Subject: Peach Bottom Atomic Power Station, Unit 2  
License Change Application ECR 00-00759

**LICENSE CHANGE APPLICATION  
ECR 00-00759**

**"Revision of SLMCPRs"**

Figure 1 Reference Core Loading Pattern – Cycle 13

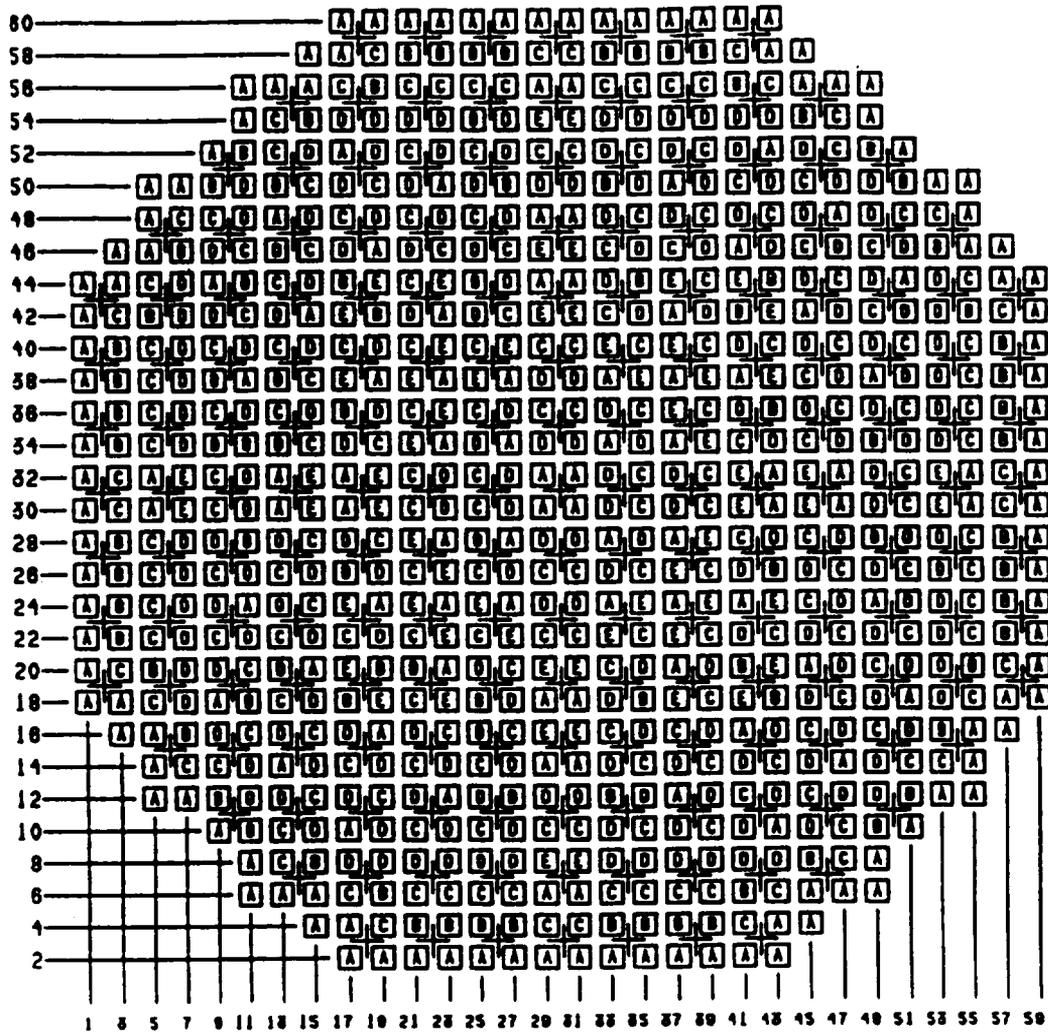
*1. Provide the fuel types and numbers of assemblies used in Peach Bottom 2 Cycle 14 operation and identify if they are fresh or irradiated fuel (once or twice burned, etc.). Also, provide the fuel loading pattern for Cycle 14 and identify its difference from Cycle 13 and the impact on the SLMCPR calculation.*

The requested core loading information is provided as Figures 1 and 2. The impact of the fuel loading pattern differences on the calculated SLMCPR is correlated to the values of [[]]
